CP-200800057
Log # TXX-08008

SUBJECT: COMANCHE PEAK STEAM ELECTRIC STATION
DOCKET NOS. 50-445 AND 50-446
SUPPLEMENT TO LICENSE AMENDMENT REQUEST (LAR) 07-004
REVISION TO THE OPERATING LICENSE AND TECHNICAL SPECIFICATION 1.0,
"USE AND APPLICATION" TO REVISE RATED THERMAL POWER FROM 3458 MWT
TO 3612 MWT
(TAC NOS. MD6615 AND MD6616)

RESPONSE TO REQUEST FOR ADDITIONAL INFORMATION

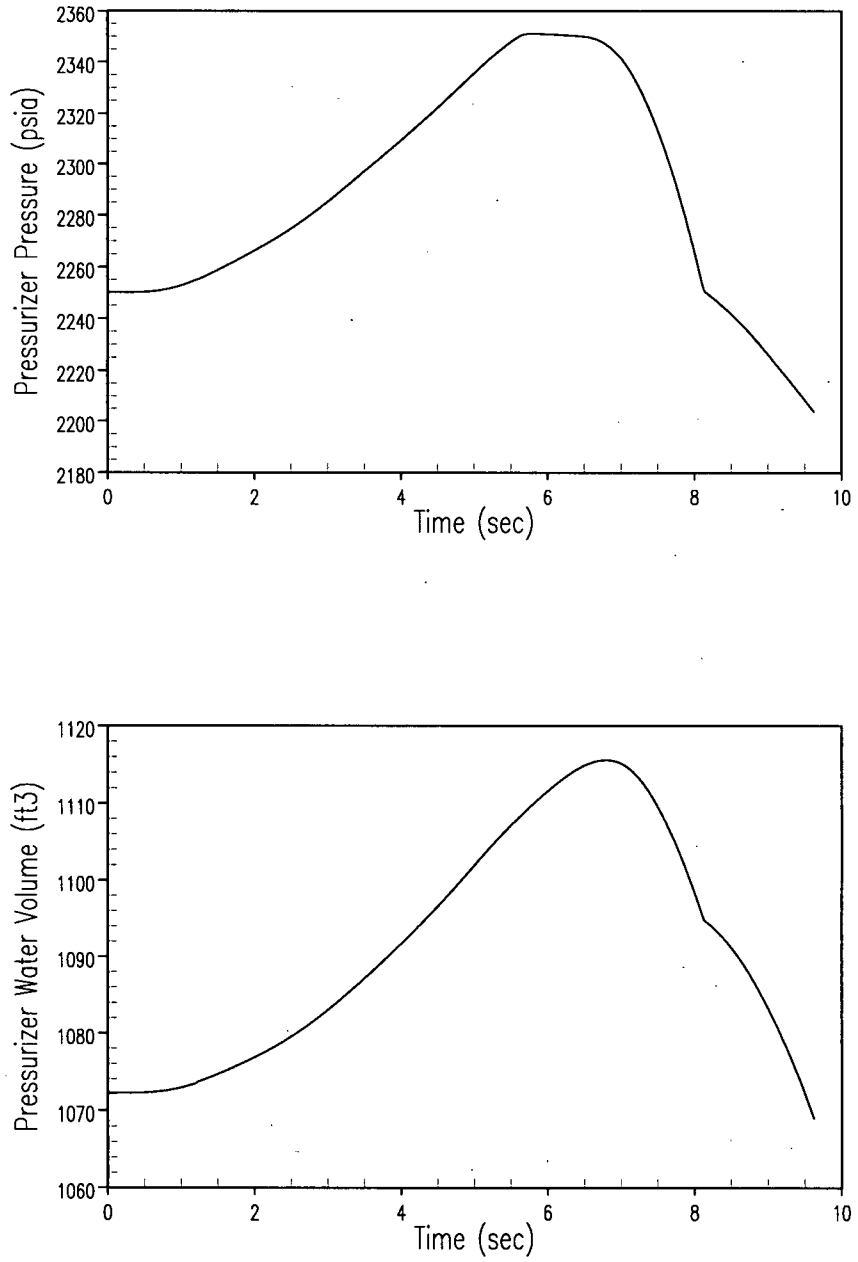
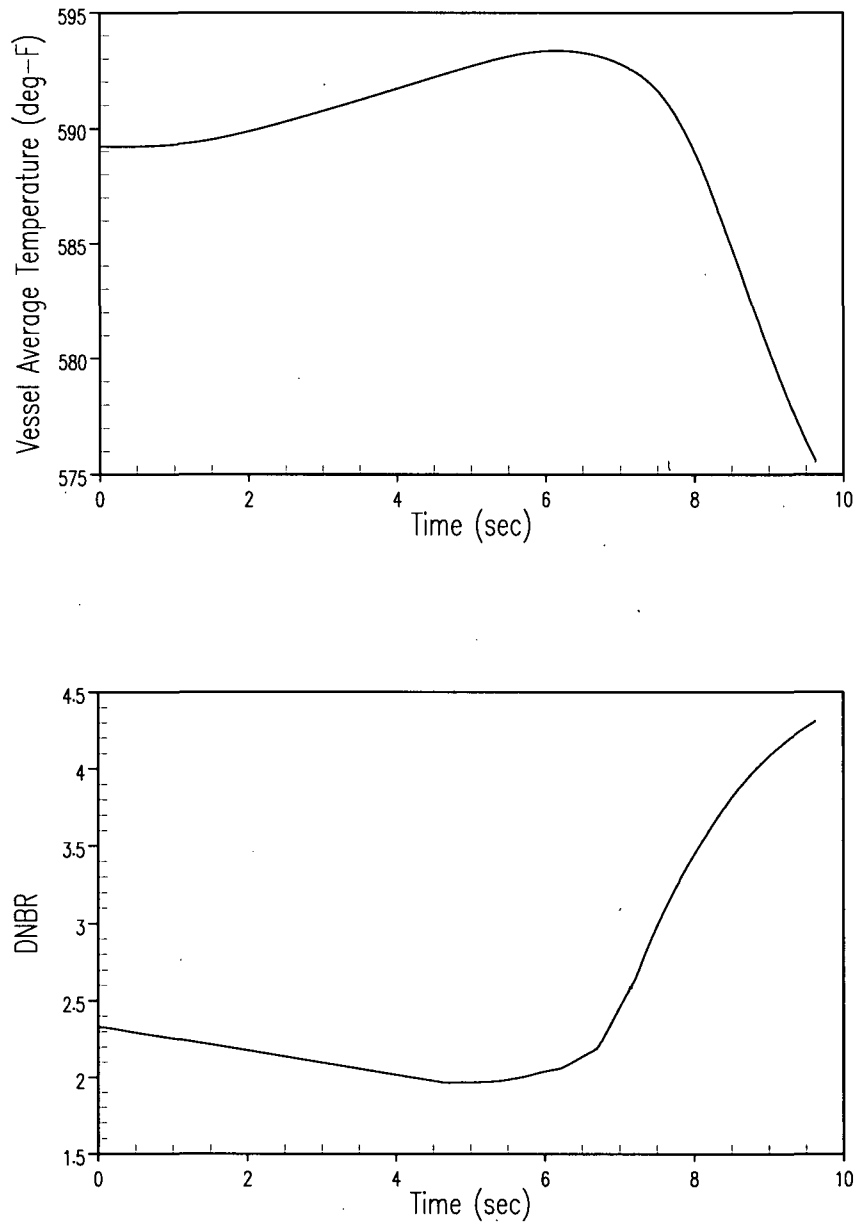
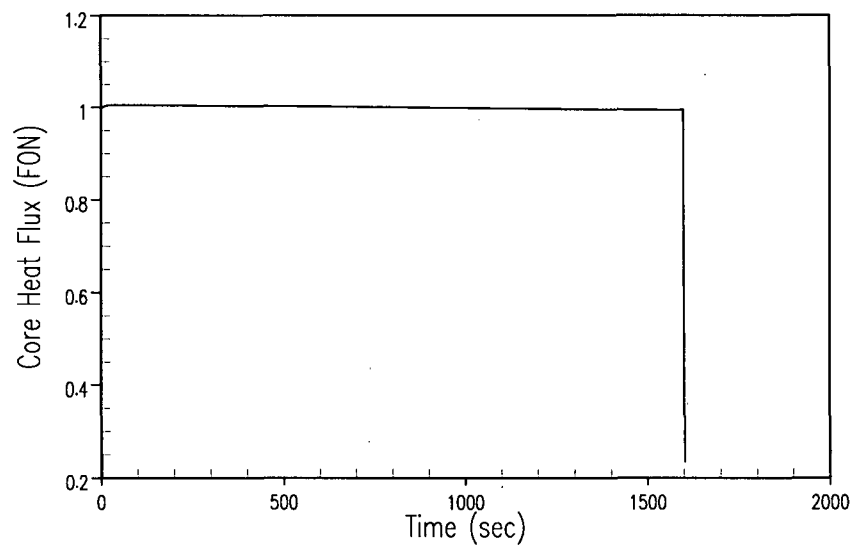
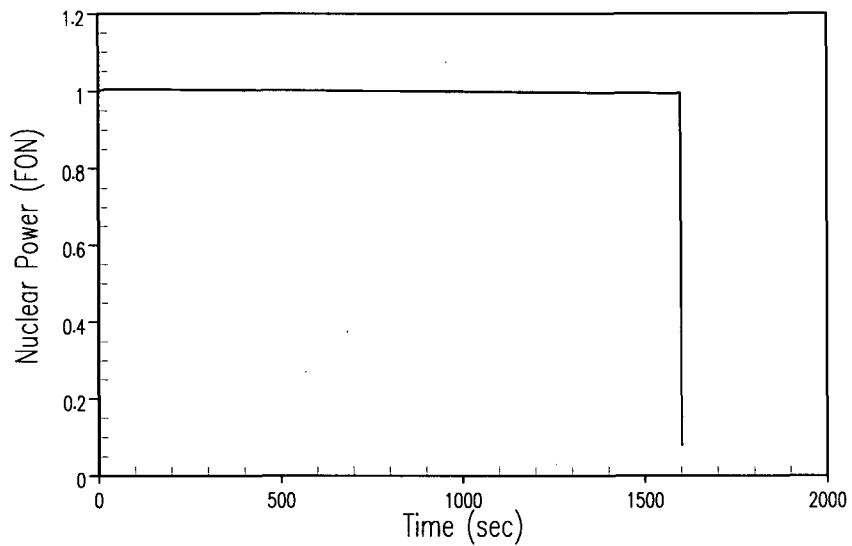
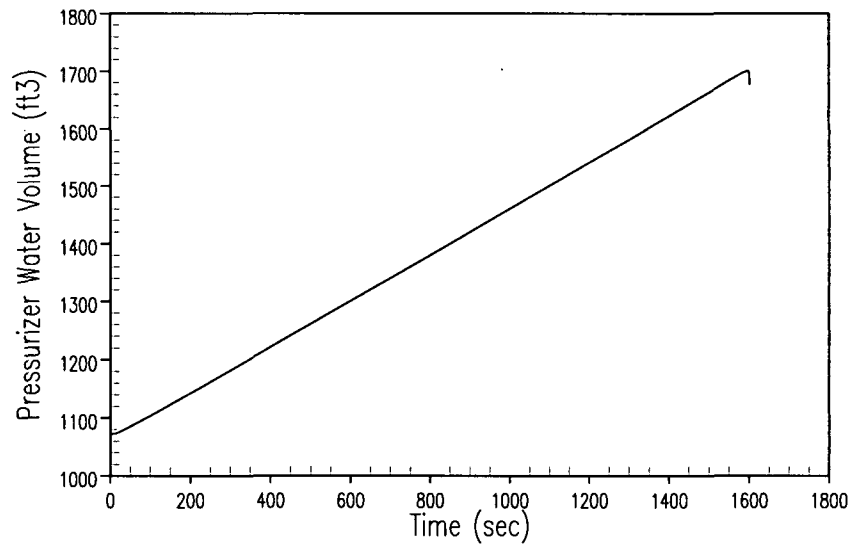
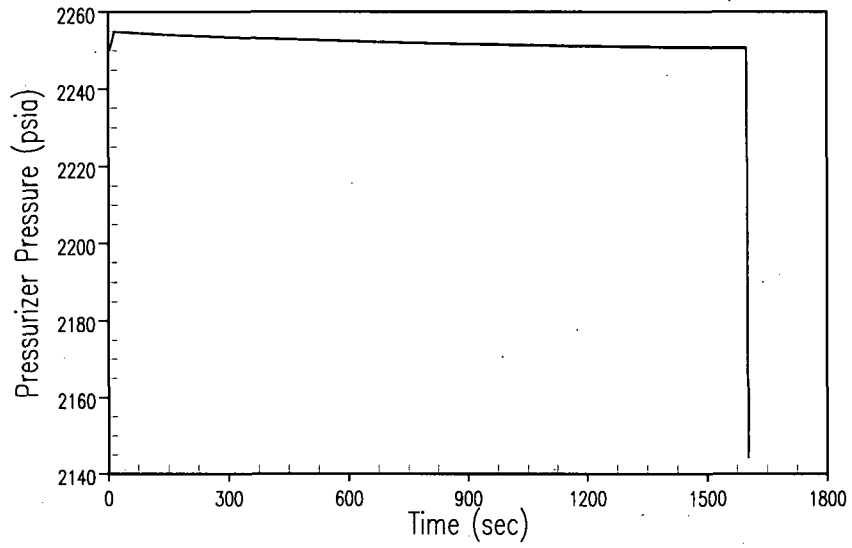
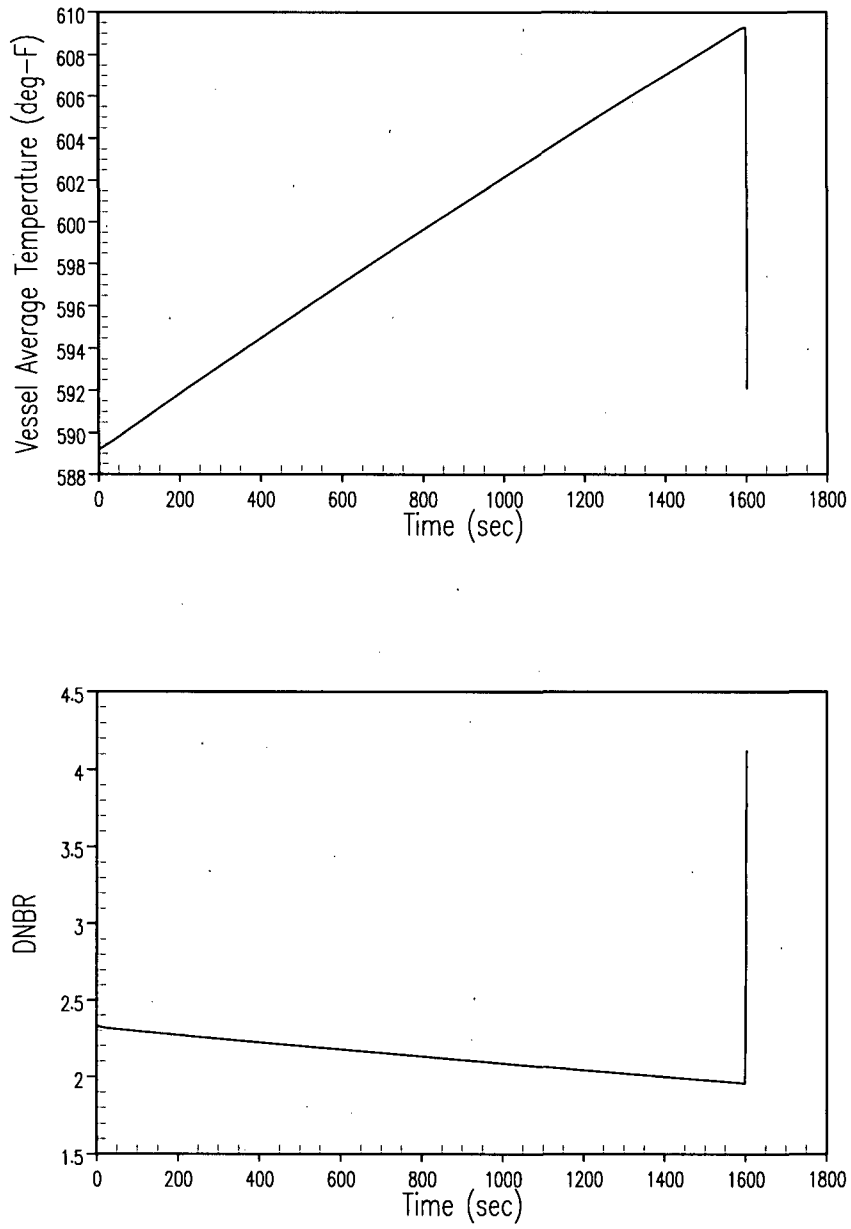
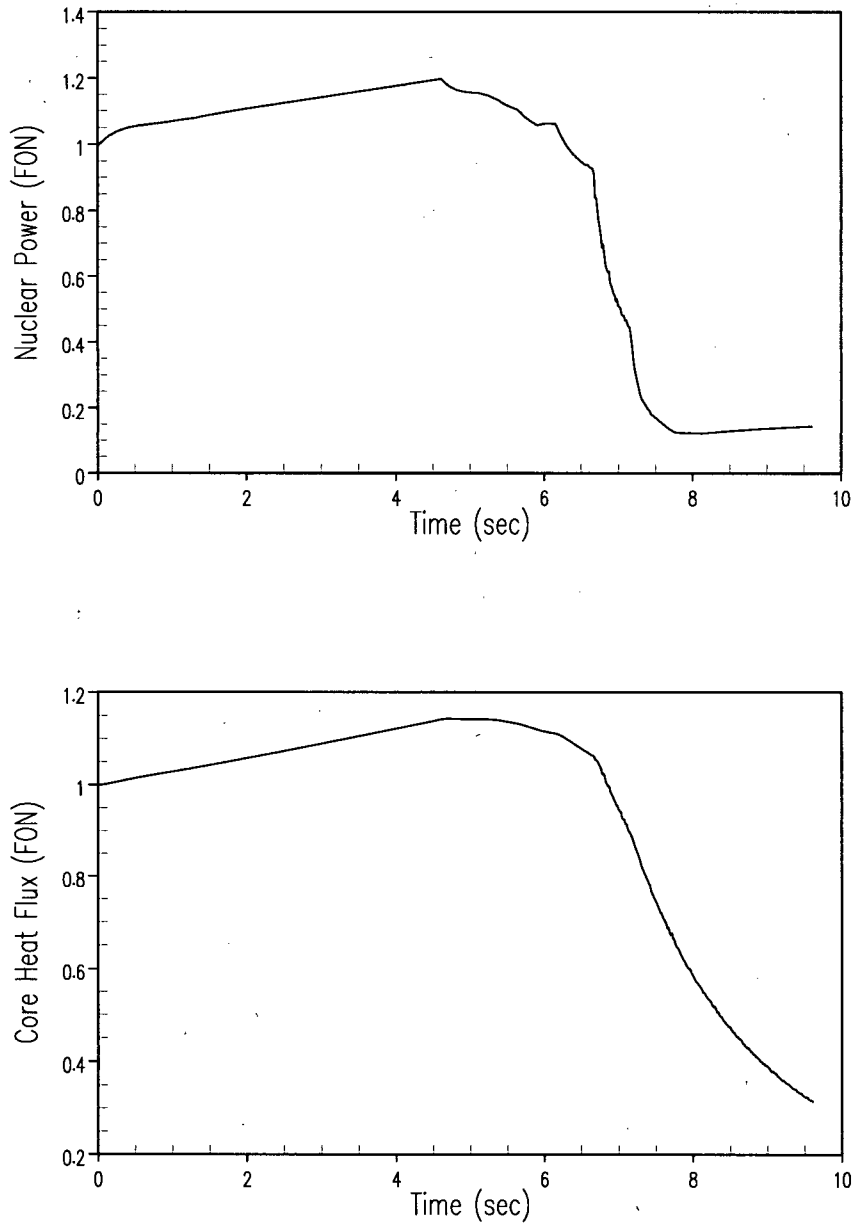
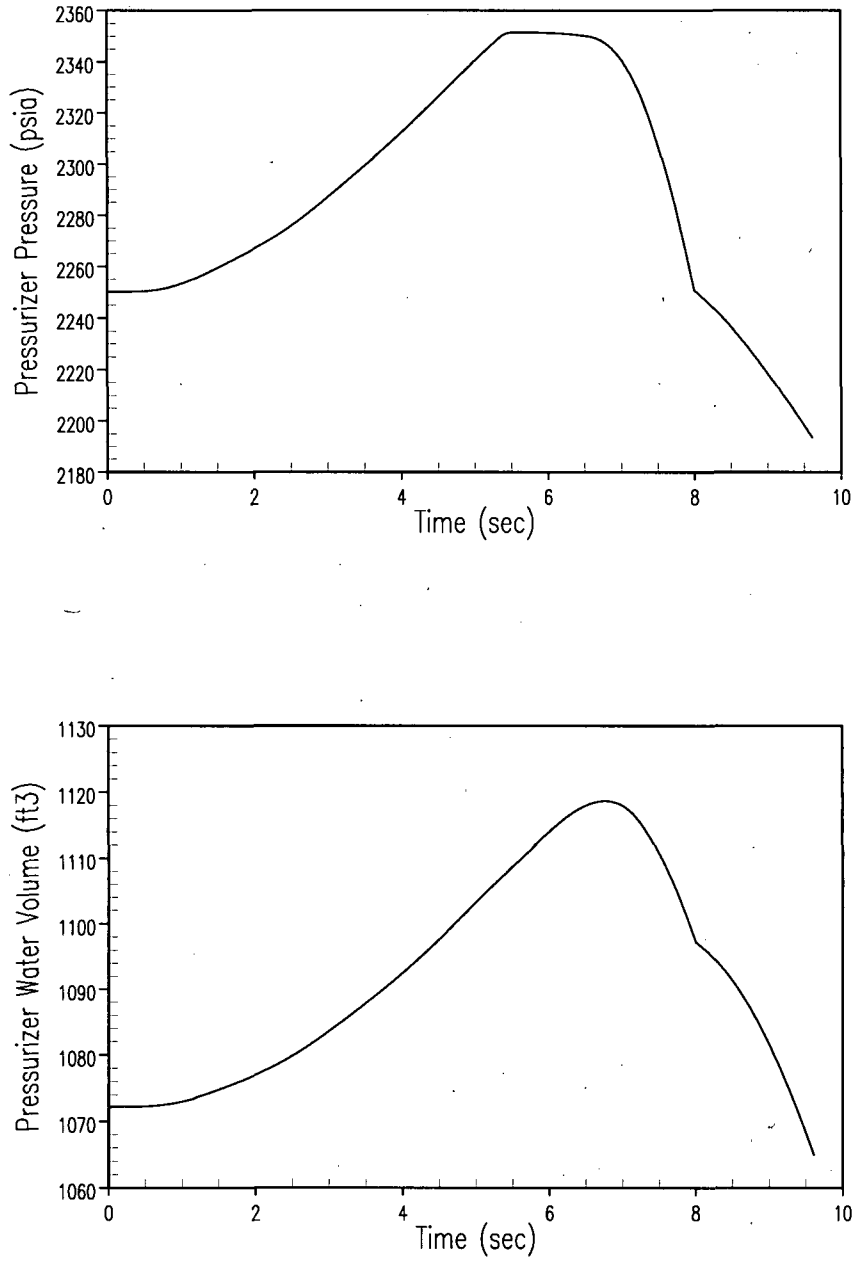
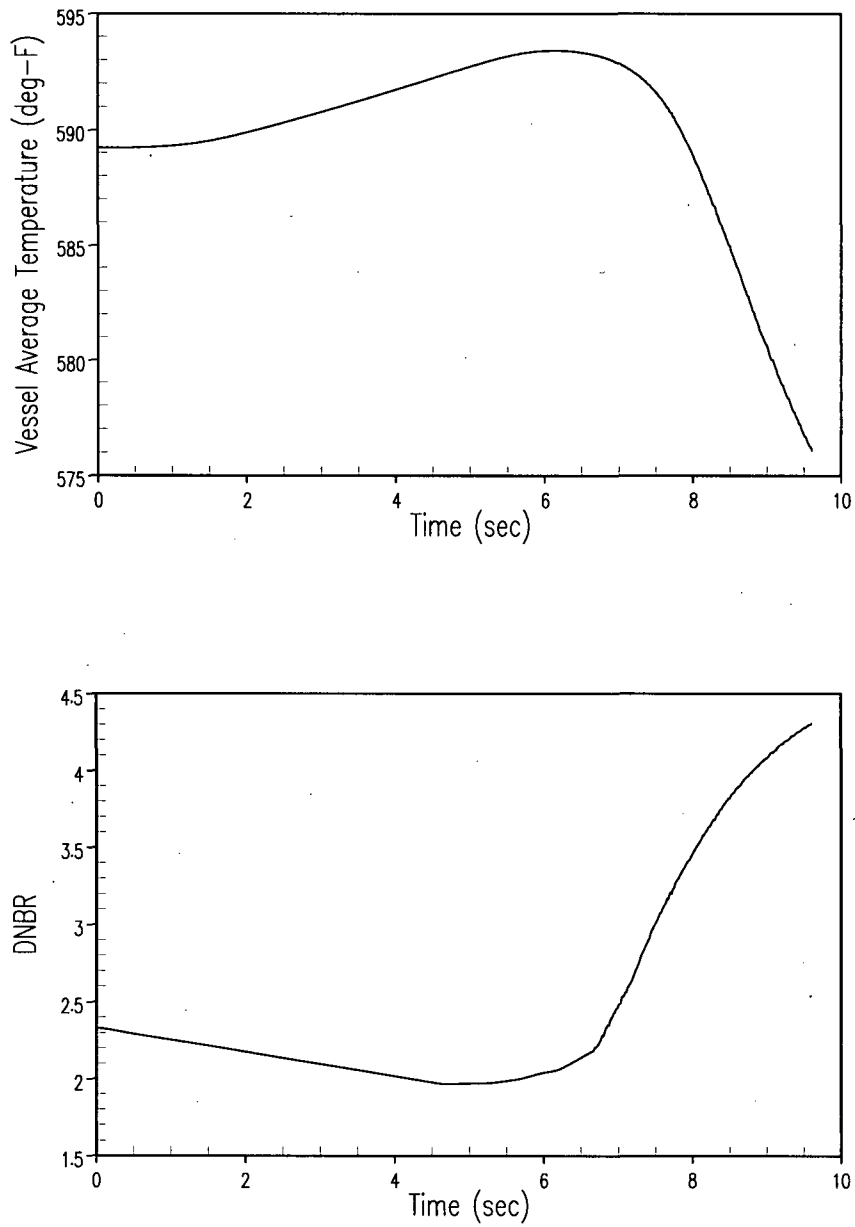
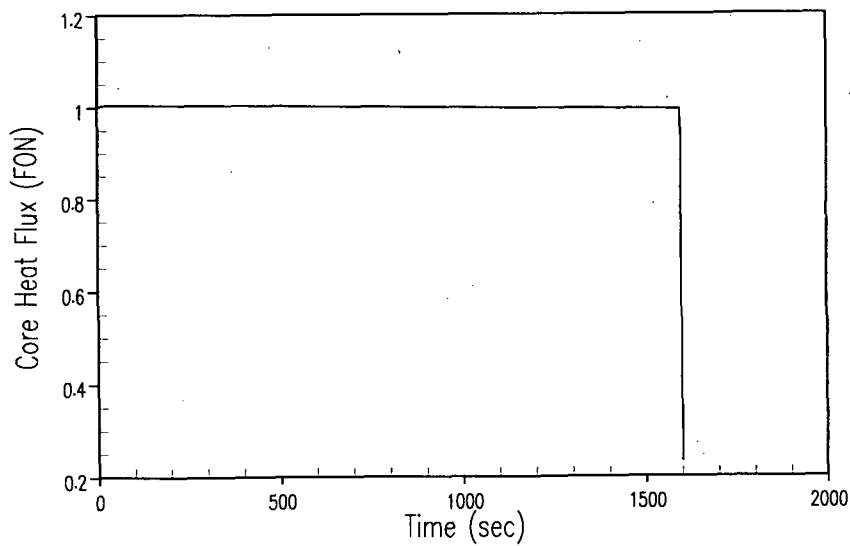
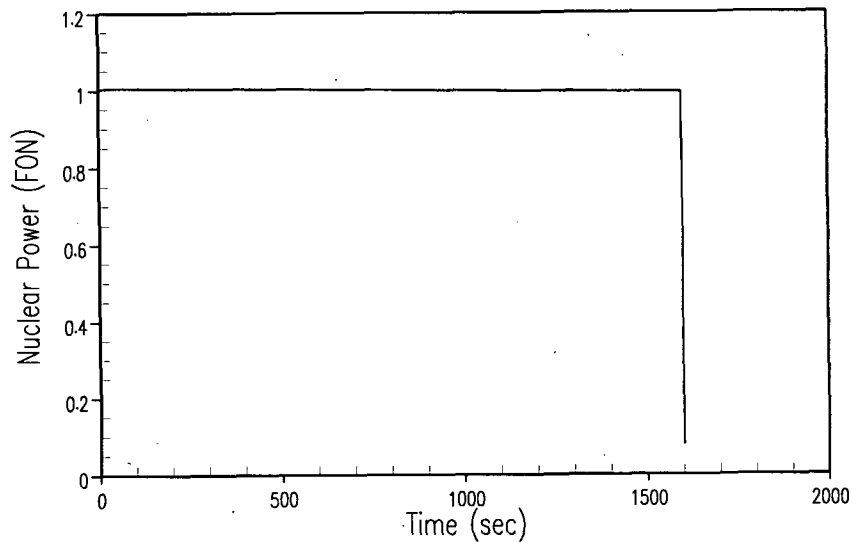
The SPULR states that two cases for minimum and maximum reactivity feedback were analyzed. The staff was unable to locate the results for the maximum reactivity feedback case. Provide these results.

The requested results are provided in the attached revision to Section 2.8.5.4.2 (Uncontrolled Rod Cluster Control Assembly Bank Withdrawal at Power). This section was recently revised to address some isolated issues related to the corresponding analysis. As the revised analysis affected results that were presented in Table 2.8.5.0-1, Table 2.8.5.4.2-1, and Table 2.8.5.4.5-1 (Boron Dilution) of the licensing report, revised tables are also provided (See Attachments 2 and 3).

Figures 2.8.5.4.2-7 through 2.8.5.4.2-9 (Unit 1) and Figures 2.8.5.4.2-22 through Figures 2.8.5.4.2-24 for (Unit 2) show the transient response for a rapid uncontrolled RCCA bank withdrawal incident (110 pcm/sec) starting from 100 percent power with maximum reactivity feedback. The transient response for a slow uncontrolled RCCA bank withdrawal (1 pcm/sec) from 100 percent power with maximum feedback is shown in Figures 2.8.5.4.2-10 through 2.8.5.4.2-12 (Unit 1) and Figures 2.8.5.4.2-25 through 2.8.5.4.2-27 (Unit 2). The results are similar to the results of the cases with minimum reactivity feedback, but the maximum reactivity feedback leads to a slower increase in power, resulting in a longer transient.
